A RESOLUTION APPROVING THE MINOR MODIFICATION TO THE  
WINMORE CONDITIONAL USE PERMIT FOR A "DAYCARE FACILITY" AT  
515 EAST WINMORE AVENUE  
Resolution No. 14/2009-10

PROJECT: Minor Modification to Winmore CUP for "Daycare Facility" at 515 East Winmore Avenue

Date: June 27, 2009  
 To: Applicant  
 Copy: Marty Roupe, Zoning Administrator  
 From: Randy Dodd, Environmental Planner  
 Subject: Environmental Review Comments  
 Project: Rev 3 –Goddard Day Care CUP; Plans stamped June 10, 2009

**SITE PLAN**  
**GODDARD SCHOOL**  
Trademark Construction, Inc. (973) 334-6114  
503 Arch Street, Butler, New Jersey 07405  
CONDITIONAL USE PERMIT

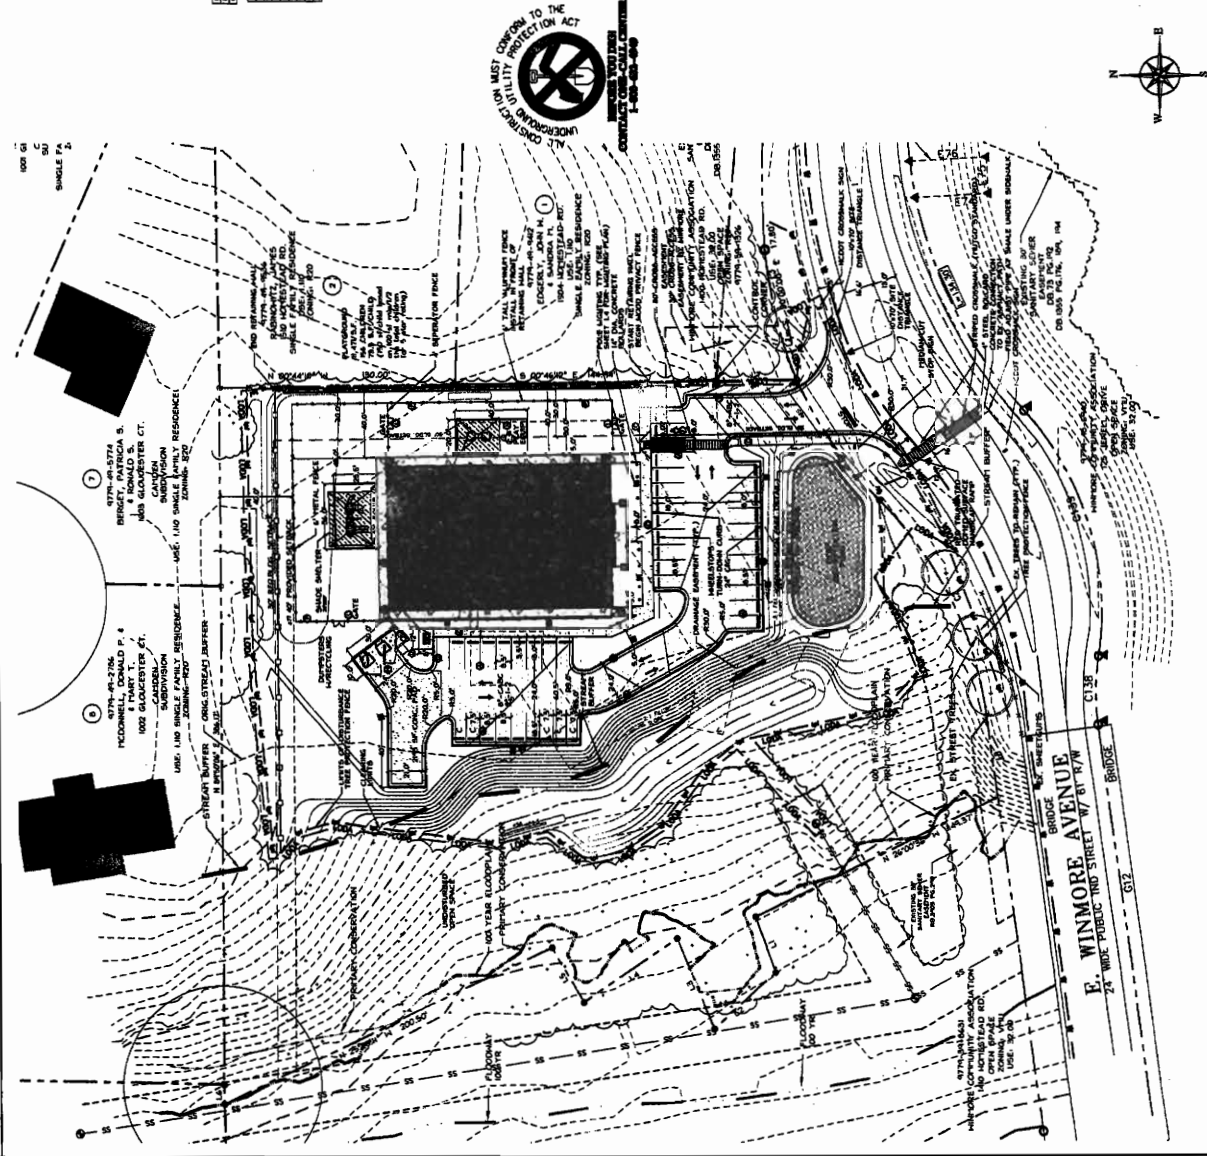
5. On Sheet L1, please clarify the basis (either on the sheet or in your response) for determining the lines showing both the original stream buffer and the stream buffer. *Addressed*
6. On Sheet L1, please in the plan show the trees to remove along with the trees to remain. Please also in the table note that the trees to remain were truncated; in future submittals please include all trees identified. *Addressed*
7. In future submittals, please include plans for tree replacement in the event of tree mortality after transplanting. *Addressed*
8. On Sheet L-2, the bike rack arrow is pointing to the recycling/trash area. Please redirect arrow. **Not addressed.**

**ARROW LOCATION CORRECTED**
